QUANTA COMPUTER	
<b>PAGE LIST</b>			
Size	Document Number	Rev	
Custom	WR1D MAIN BOARD	3A	
Date: Friday, August 25, 2006	Sheet	2	of 43

Document Number: WR1D Main Board

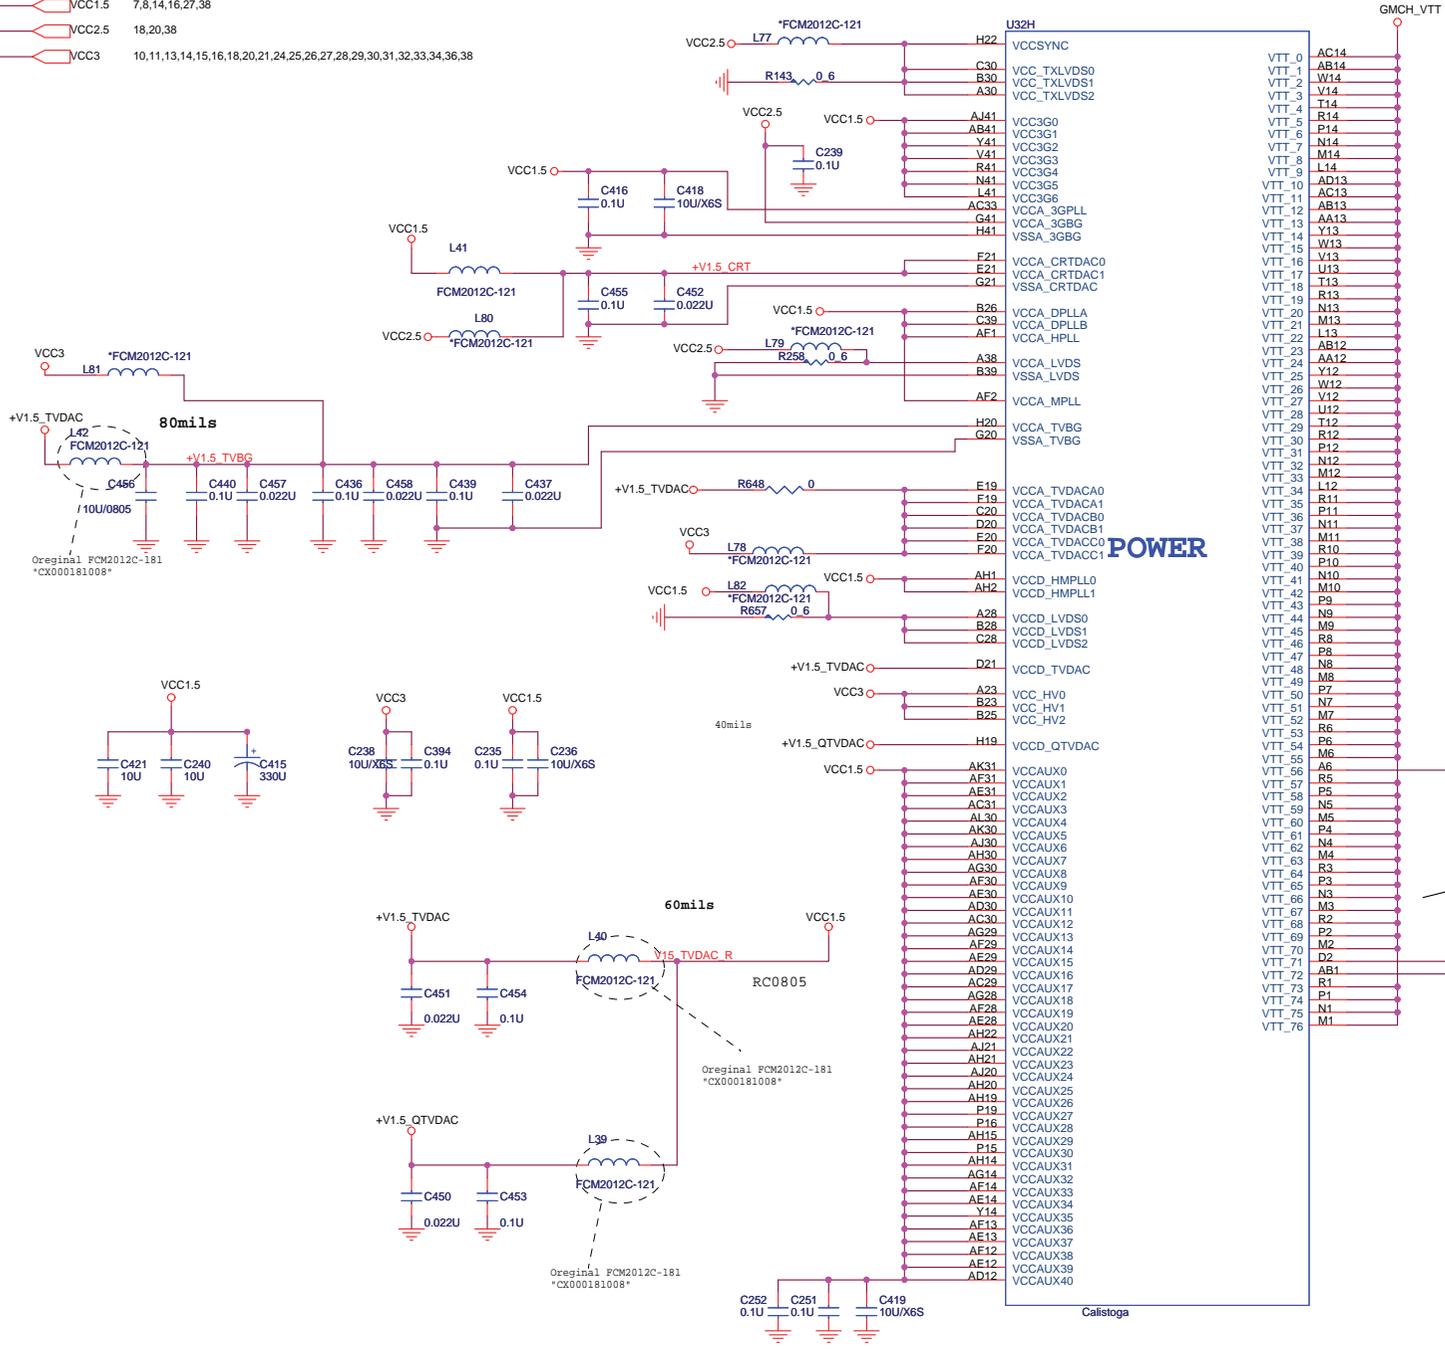
Shall Add more bypass caps for 1.05V

VTT\_56, VTT\_71 and 72 are attached with 0.1u separated .Checking

Title: **BUZZER & AUDIO/BOARD**

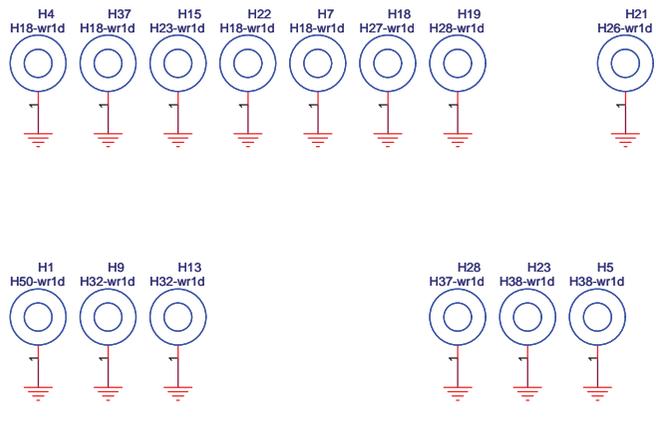
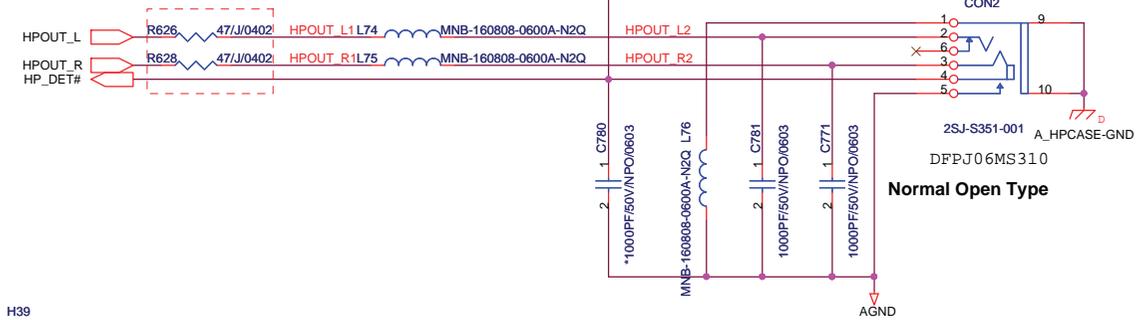
Change resistors dimension from 0603 to 0402 to prevent PCB bending cause solder and components crack issue!

Title: **Mini PCI-E / NEW Card**

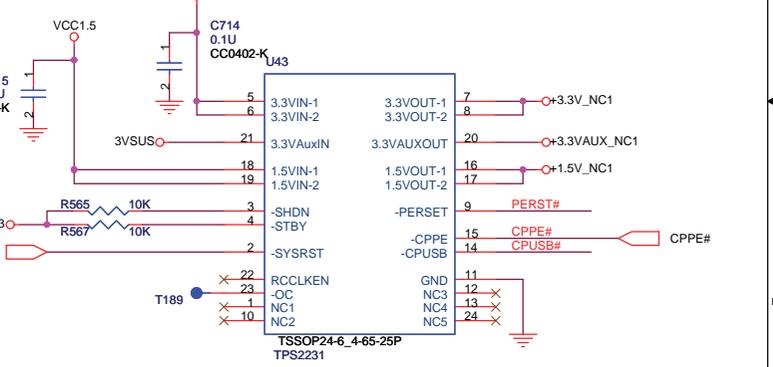
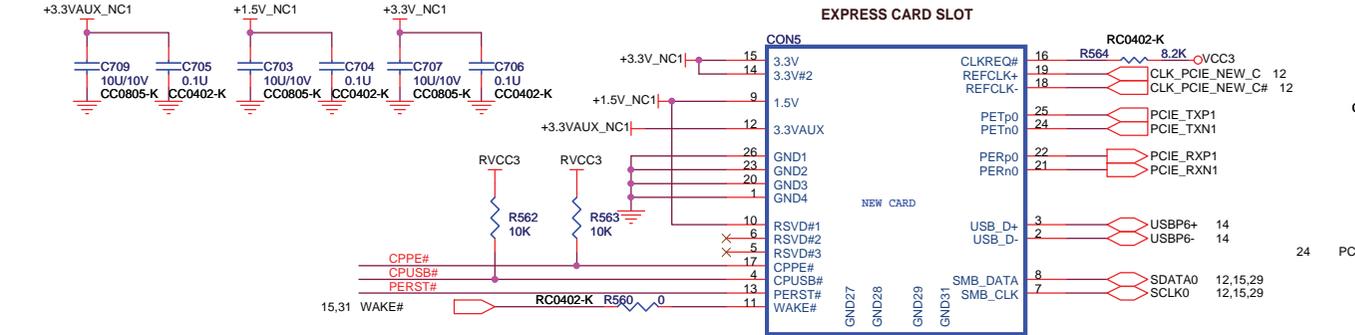
1. Pin assignments for ExpressCard connector is wrong. Please change 7 pin from RSVD#1 to SMBCLK. Please change 8 pin from SMBCLK to SMBDATA. Please change 9 pin from SMBDATA to 1.5V.
2. Please apply 100K pull-up resistor to CPPE#.
3. Please apply 100K pull-up resistor to CPUSB#.
4. Please apply capacitor (0.1uF and 10uF) to +3.3V\_NC1, +3.3VAUX\_NC1 and +1.5V\_NC1 respectively.
